WORCESTER TOWNSHIP PLANNING COMMISSION

PRELIMINARY / FINAL PLAN – HEALTH CARE NORTHEAST EXPANSION
COVER – INDEX SHEET
MEADOWOOD SENIOR LIVING
WORCESTER TOWNSHIP – MONTGOMERY COUNTY – PENNSYLVANIA
WOODROW & ASSOCIATES, INC.
MUNICIPAL / CIVIL CONSULTING ENGINEERS
1108 North Merkle Street, Suite 200
Pottsville, PA 17860
Phone: (717) 542-6648 Web: www.Woodrowinc.com

PRELIMINARY / FINAL PLAN - HEALTH CARE NORTHEAST EXPANSION
RECORD PLAN - OVERALL TRACT
MEADOWOOD SENIOR LIVING
WORCESTER TOWNSHIP - MONTGOMERY COUNTY - PENNSYLVANIA

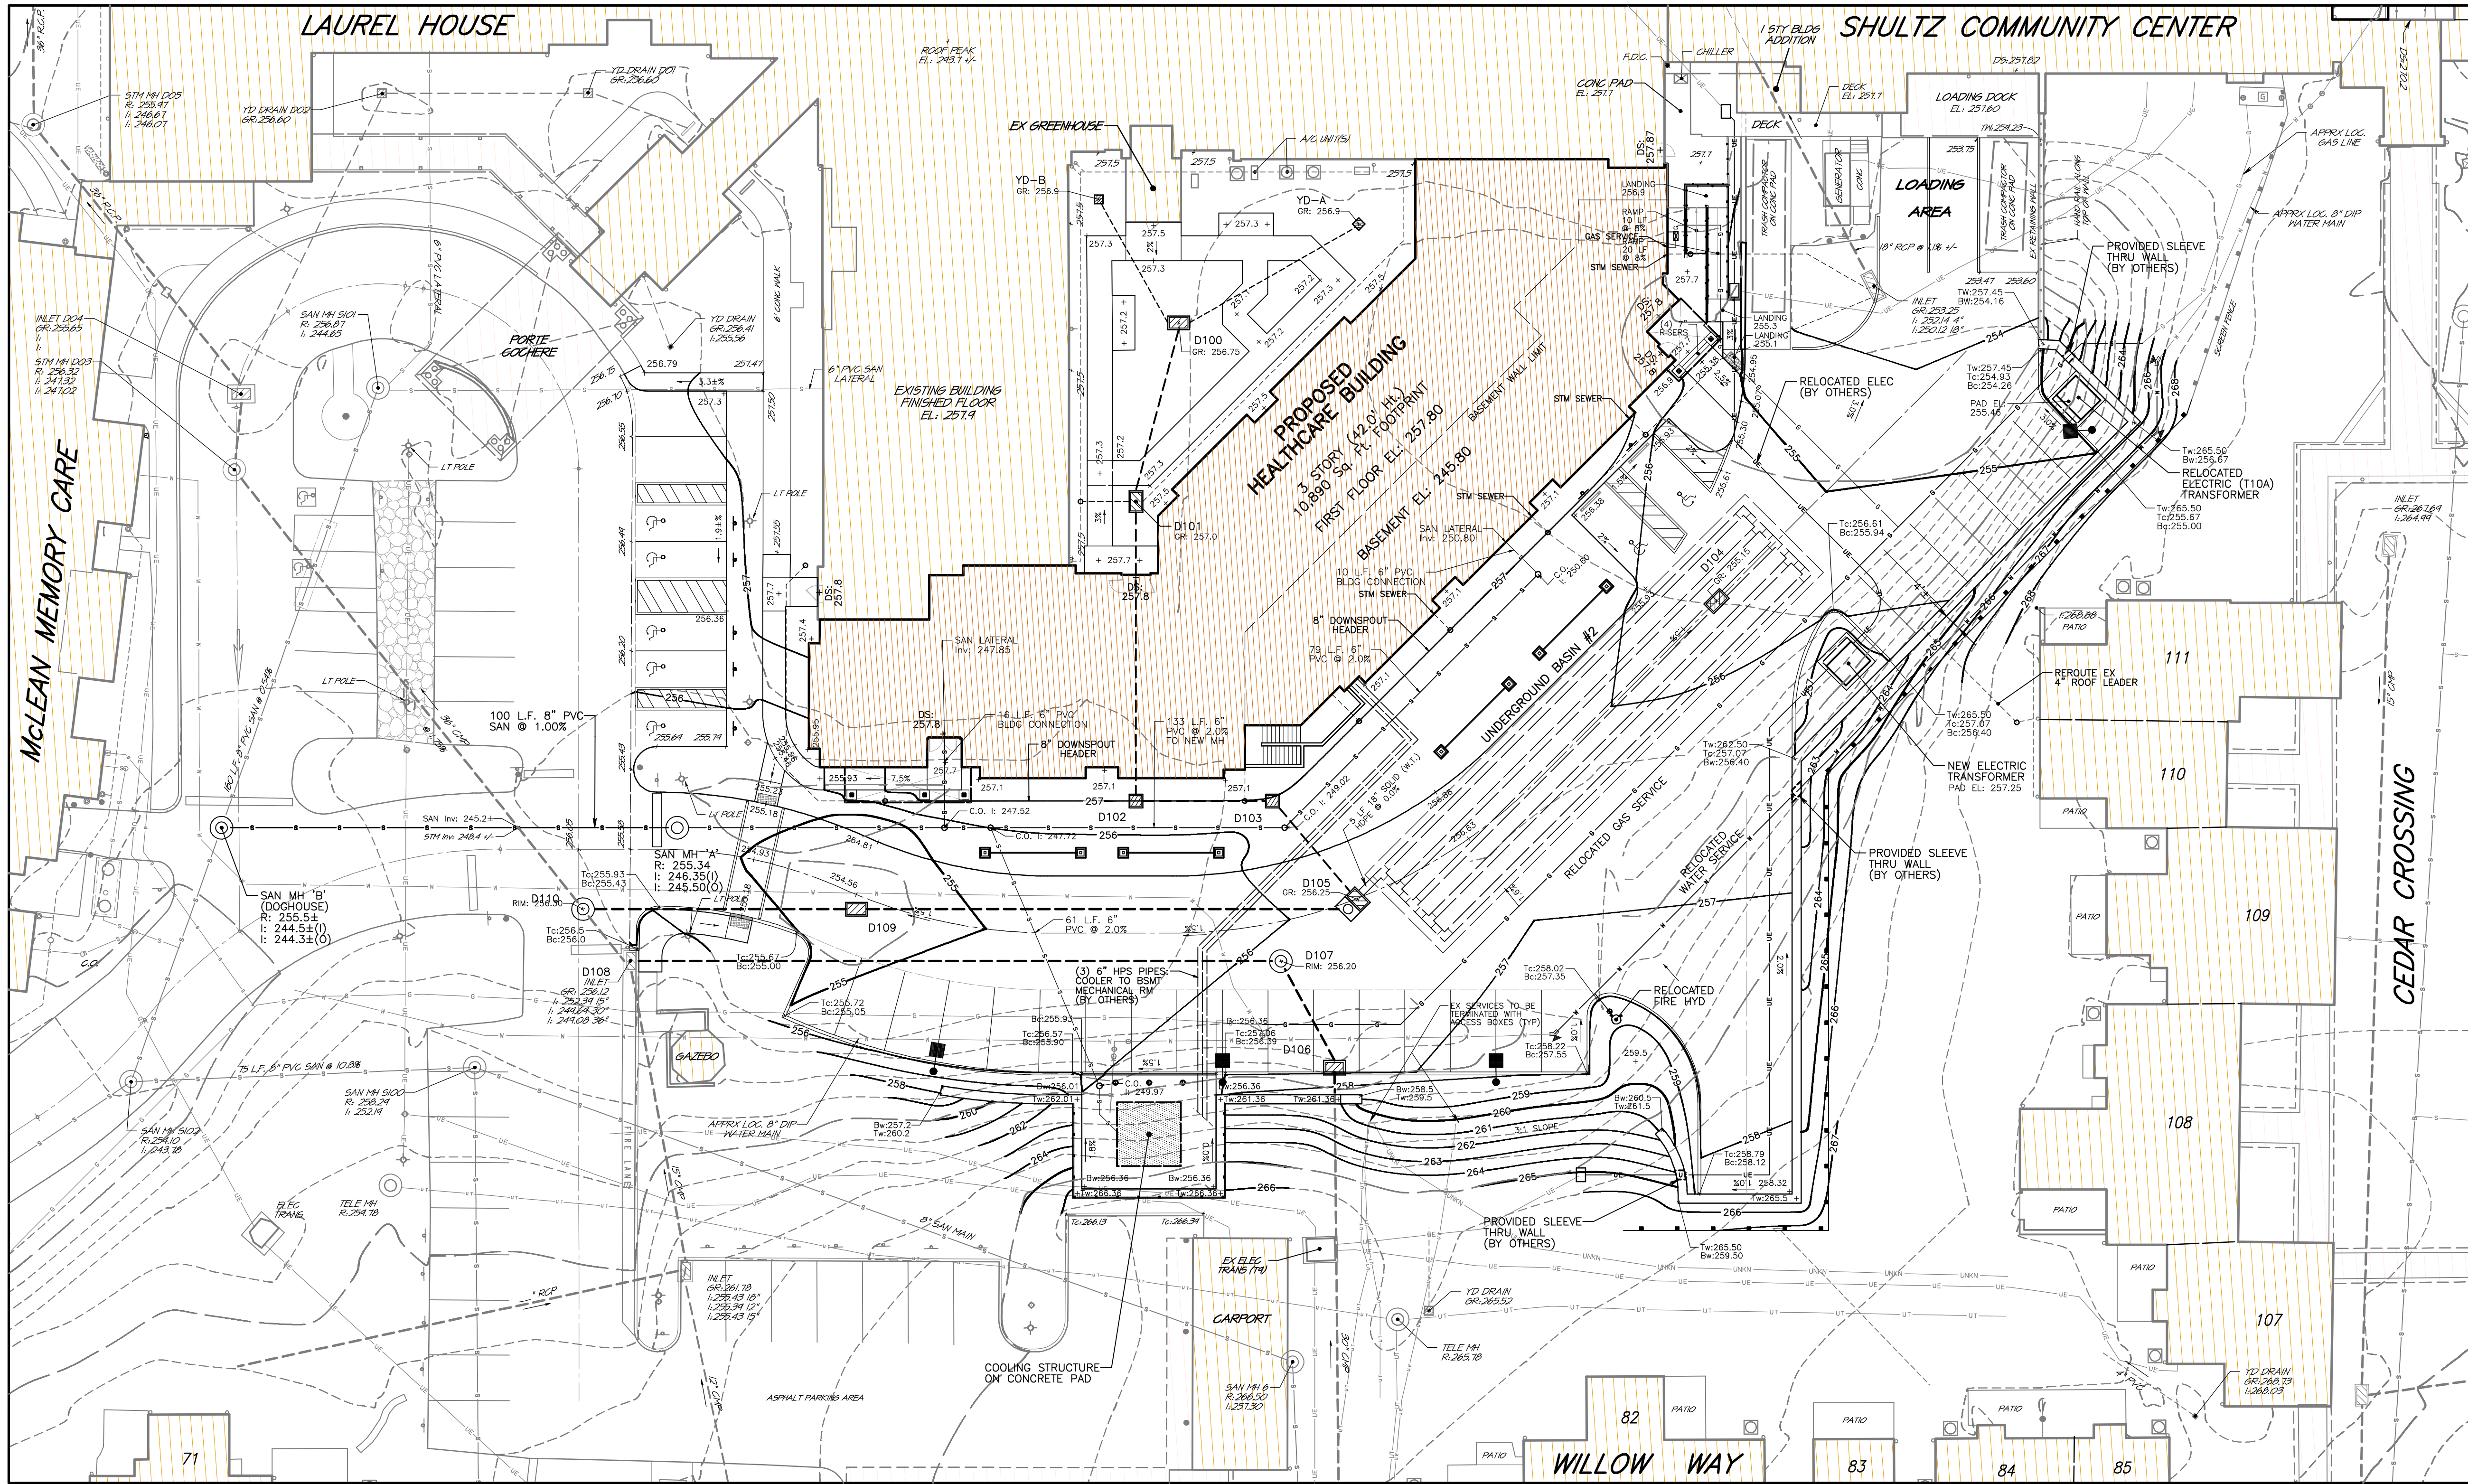
4. *The proposed courtyard is labeled as landscaped on Sheet 5. Details of the landscaping should be provided on the landscaping plan, Sheet 8.*

2. Per the Development Impervious Schedule on Sheet 5, the proposed improvements yield a net increase of impervious surface coverage of 4,971 square feet, which would require stormwater volume infiltration. Due to the location of the improvements, infiltration in the proposed improvement area is not feasible. While other BMPs that are located throughout the site may compensate for the volume requirement, it was recommended that the required volume removal for this project be included in the following phase of this project. This must be noted on the plans.

Notation added to reference schedule on Sheet 5.

Structural design for the wall to be provided by others. The requested note has been added as note #10 on plan sheet 5.

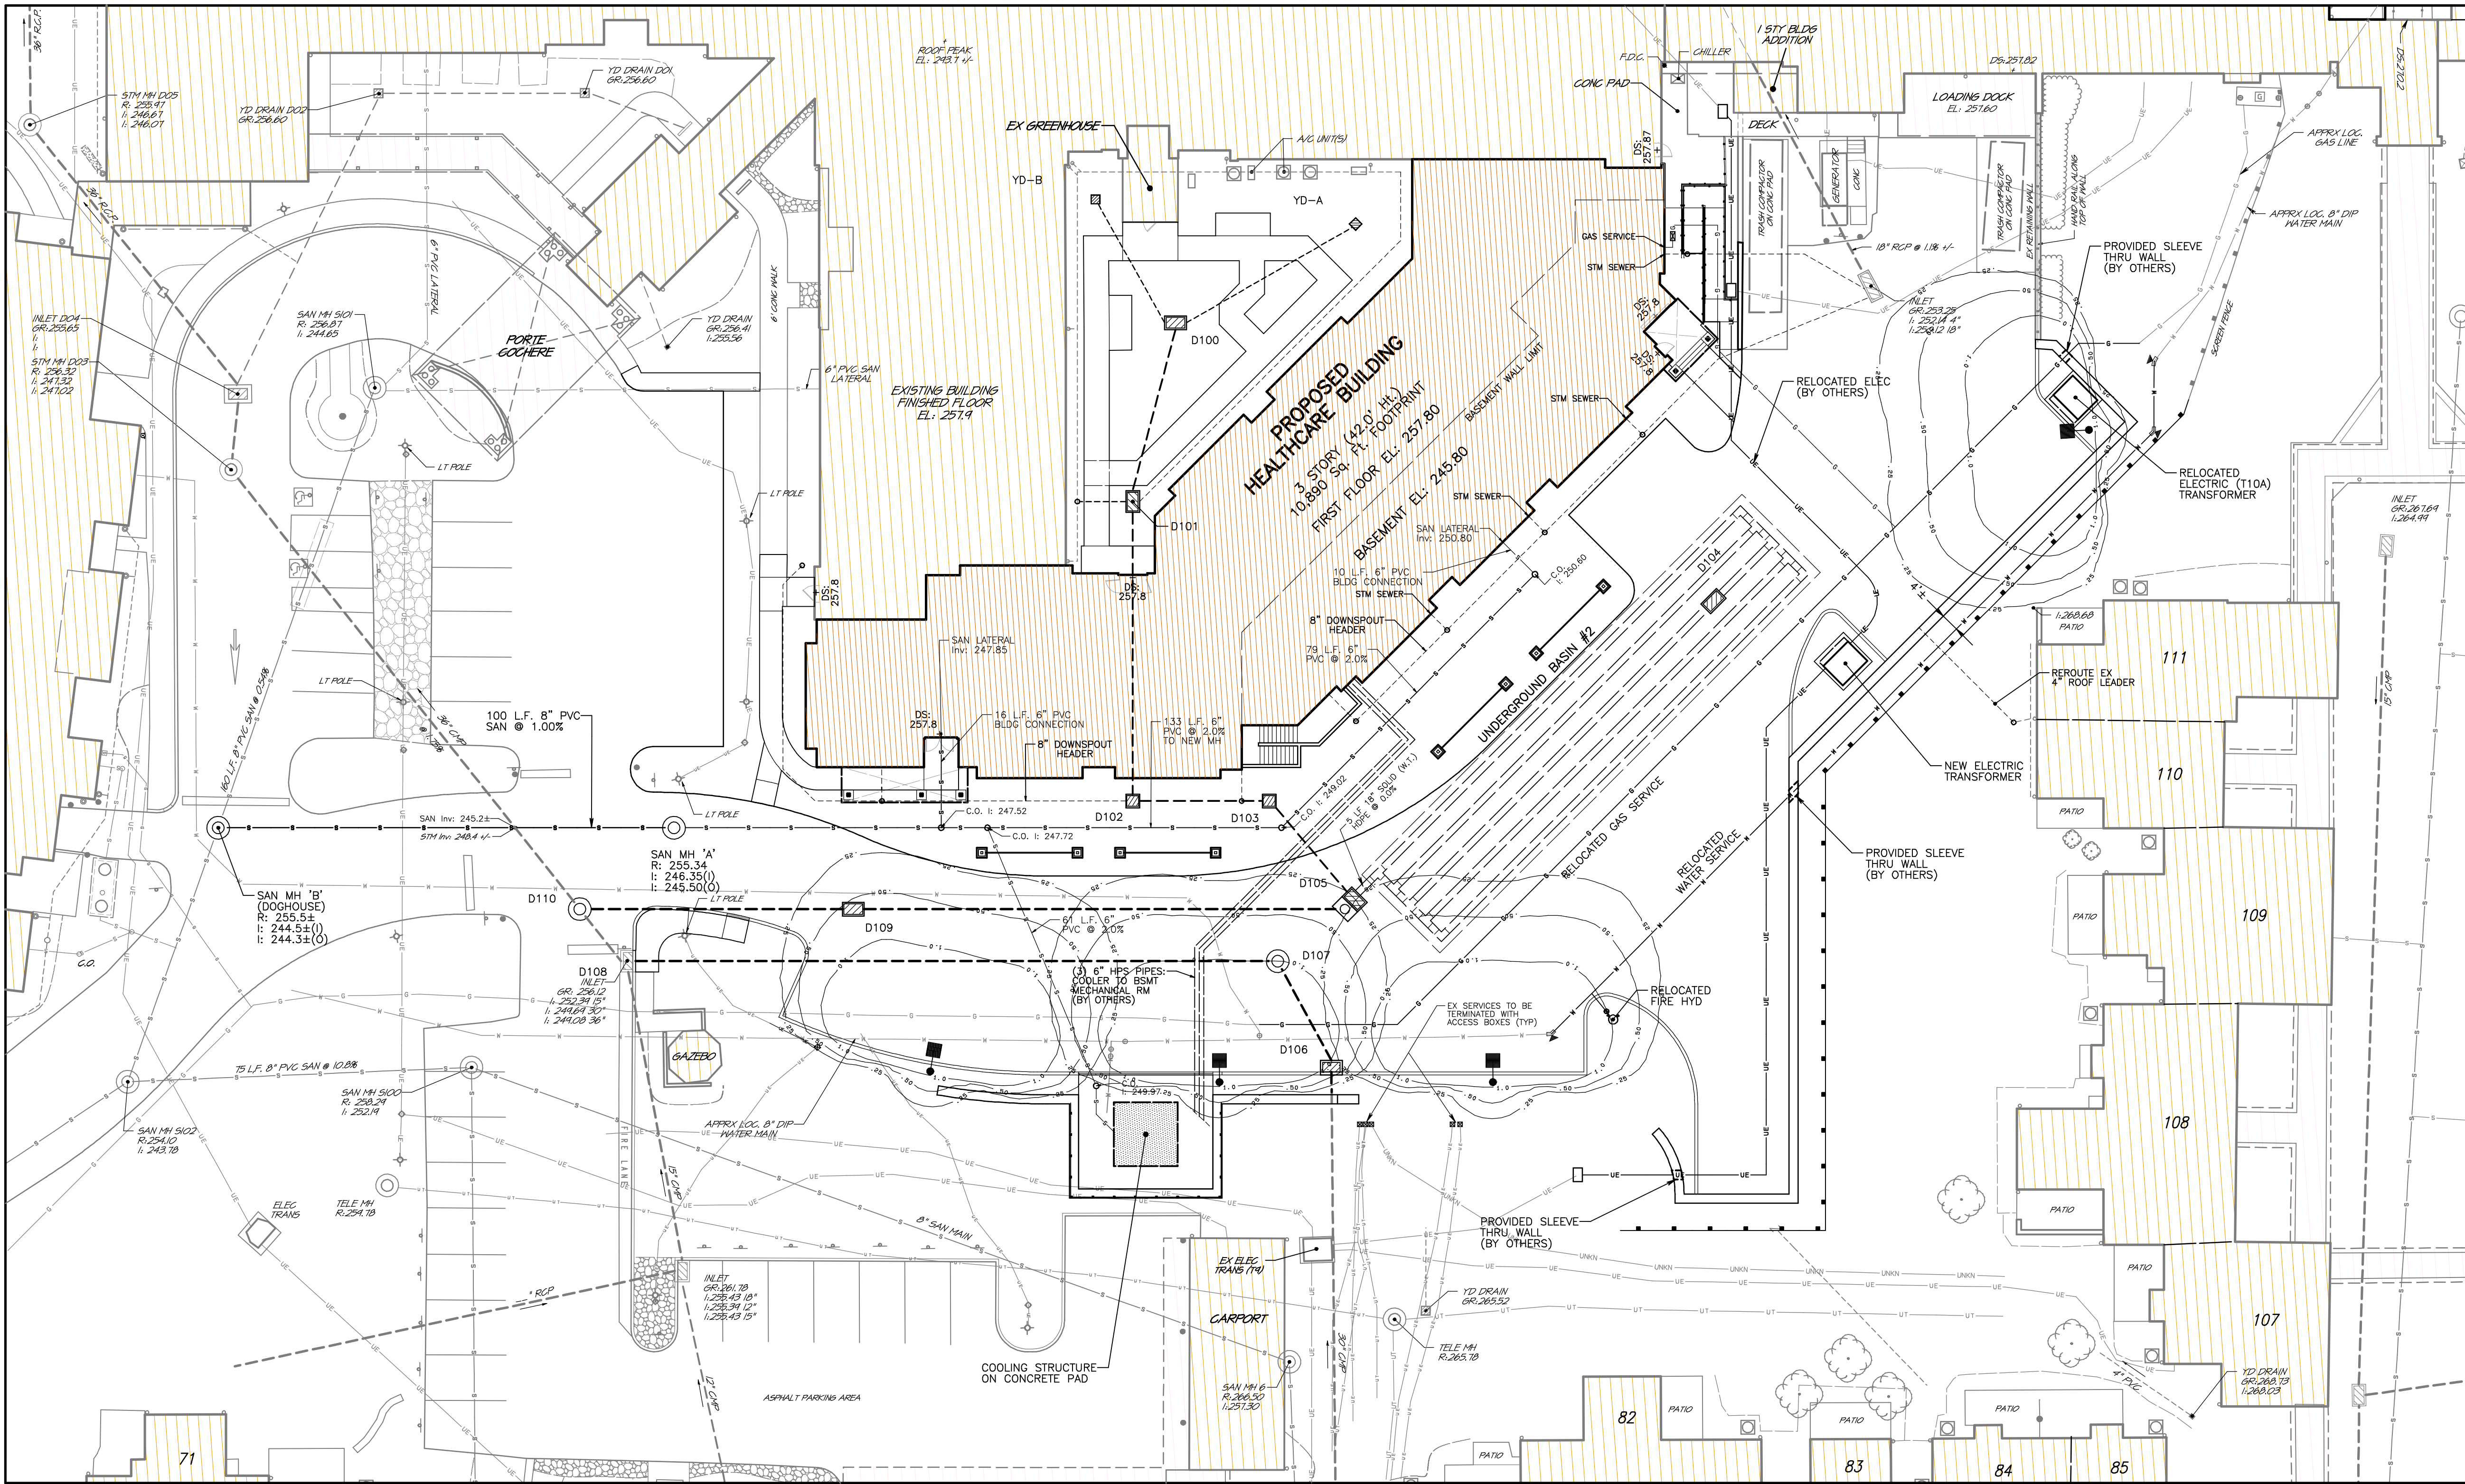
4. The rim of manhole D107 is noted as 256.20 in plan view but listed as 256.15 in the Stormwater Structure Schedule on Sheet 6. The rim elevation must be consistent.
